**Official Transcript of Proceedings**  
**NUCLEAR REGULATORY COMMISSION**

Title:                   Advisory Committee on Reactor Safeguards  
                              ESBWR Subcommittee: North Anna COLA

Date:                    Friday, August 21, 2009

7 MEETING OF THE ESBWR SUBCOMMITTEE ON THE NORTH ANNA

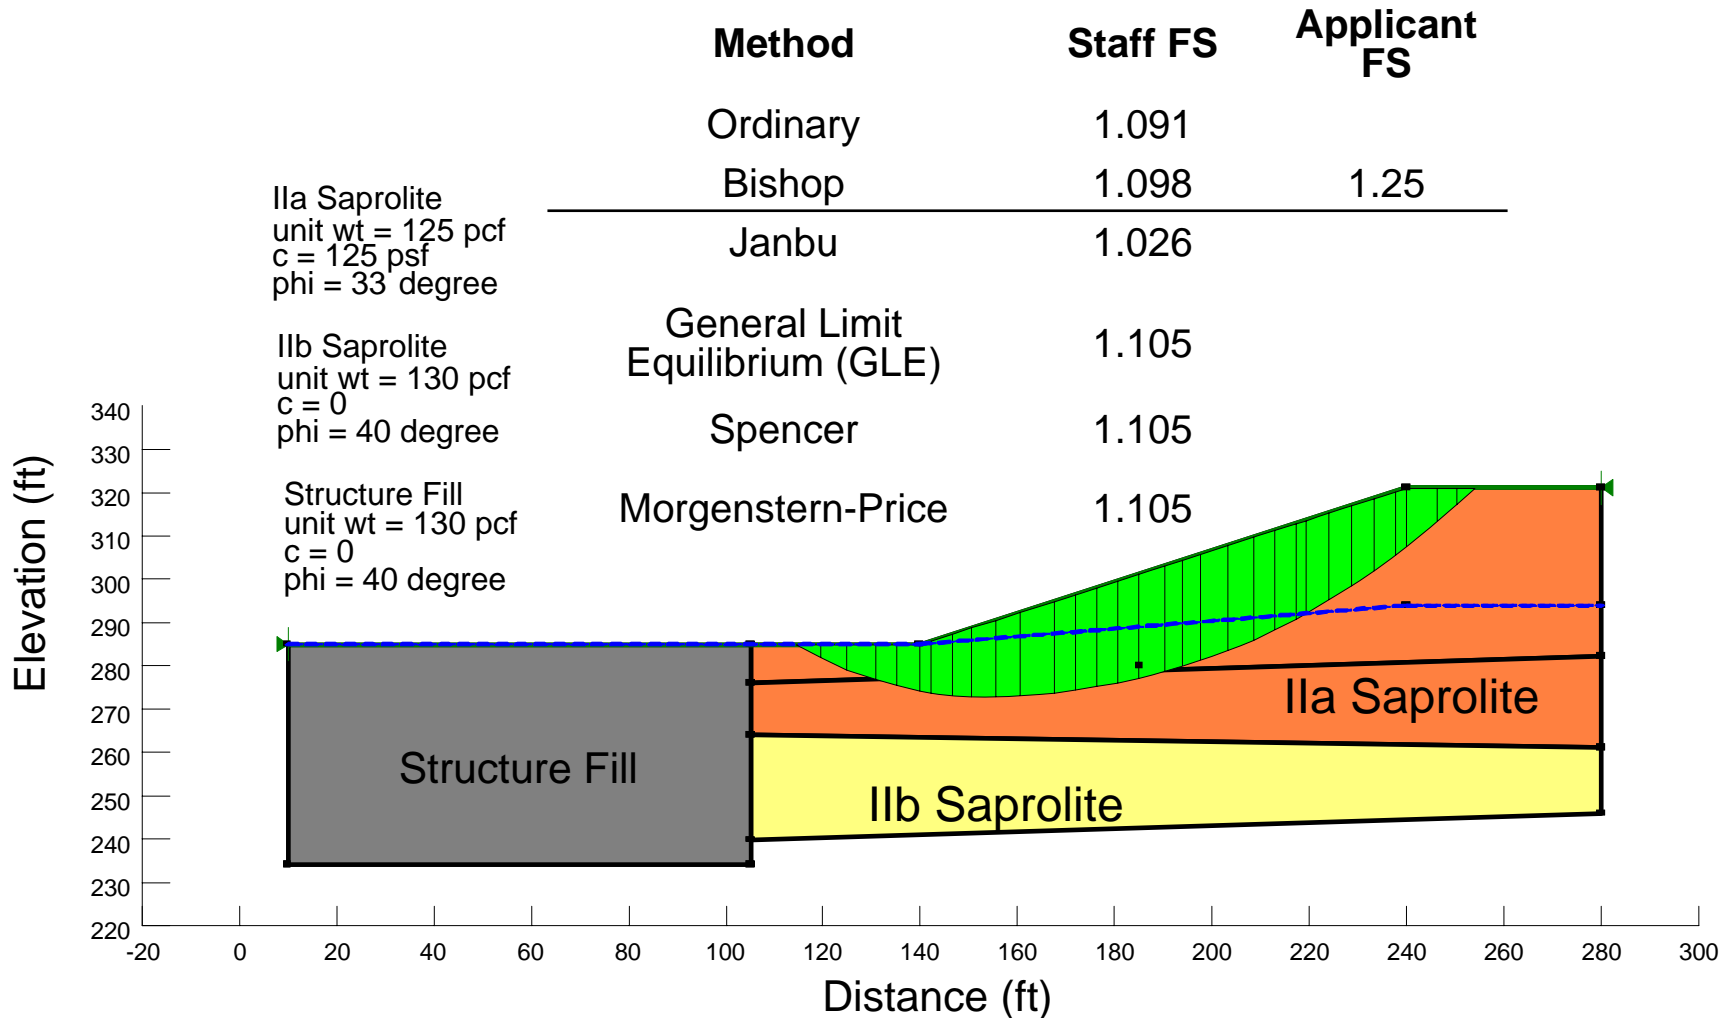
- **2.5.4 Stability of Subsurface Materials and Foundations Open Items (OI)**
  - **OI 2.5.4-3 and 6:** Lack of information on concrete fill
  - **OI 2.5.4-4 and 5:** Did not adequately characterize the static and dynamic properties of the backfill soil (ITAAC issue) including minimum shear wave velocity determination
  - **OI 2.5.4-7 and 11:** Did not address the possibility of local failure in foundation stability analysis, and justify dynamic bearing capacity
  - **OI 2.5.4-8:** Did not clarify the site-specific coefficient of friction at foundation interface
  - **OI 2.5.4-10:** Did not clearly explain why estimated dynamic settlement in ESP SSAR is almost 3 times of that in COL FSAR

# Staff Stability of Slopes Confirmatory Analysis

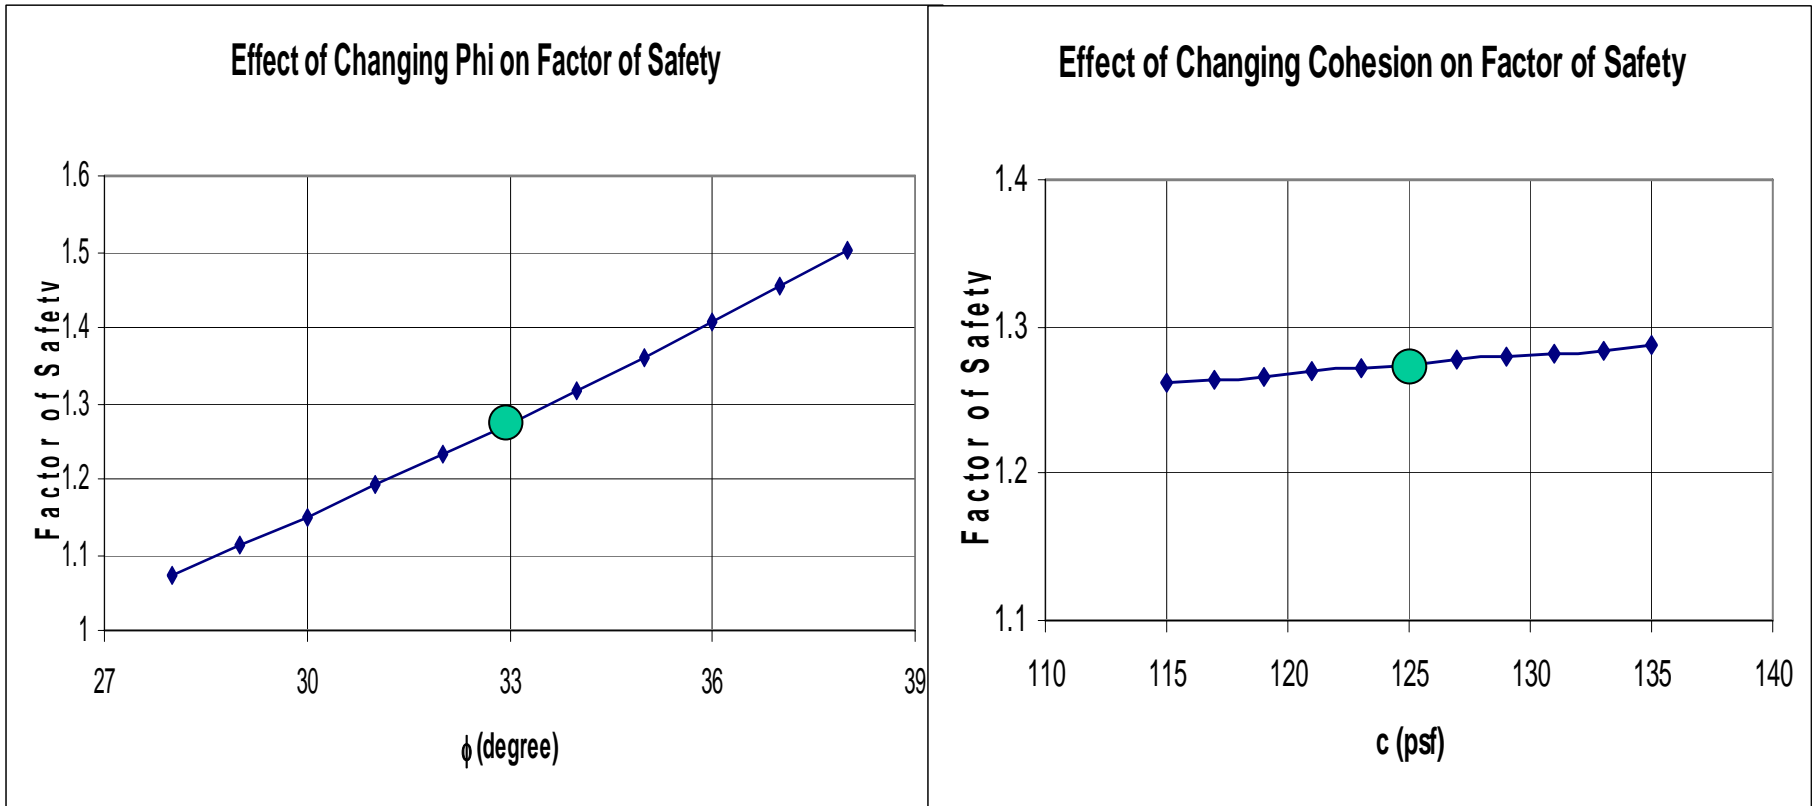
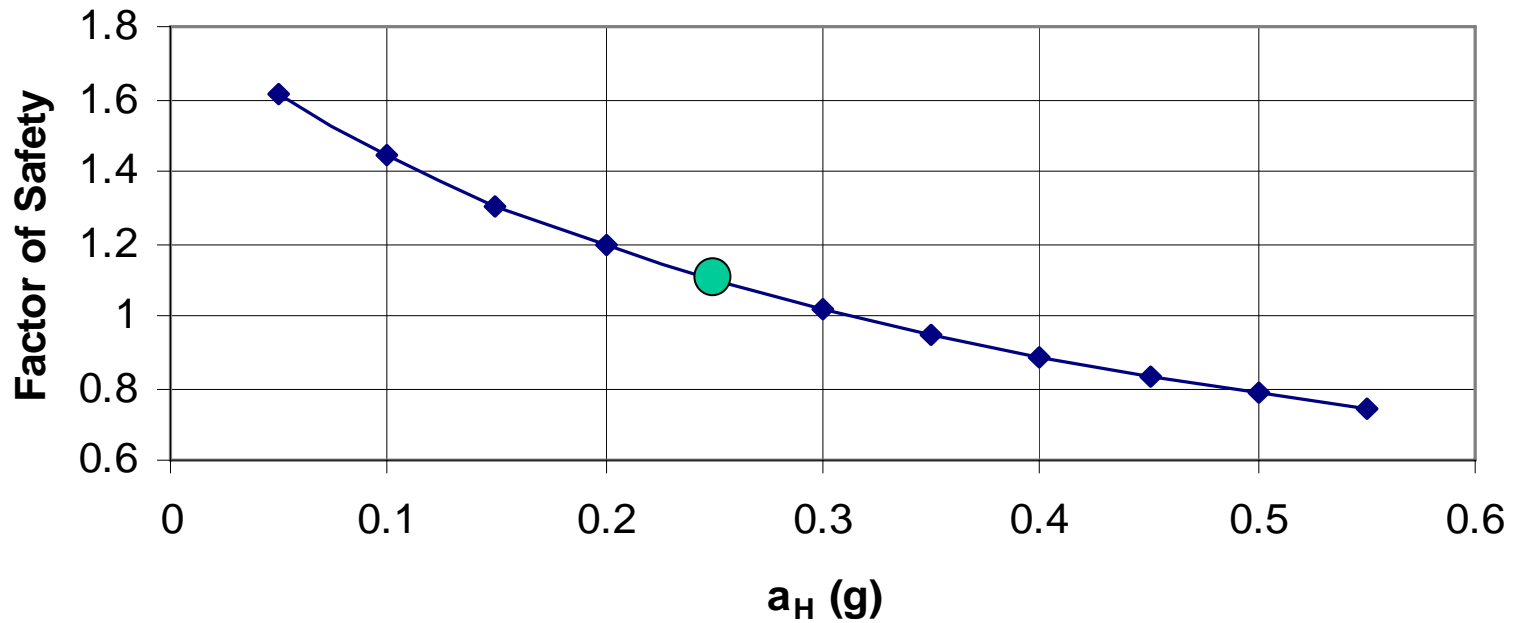
● Applicant used value

## Effect of Changing Horizontal Seismic Force on Factor of Safety
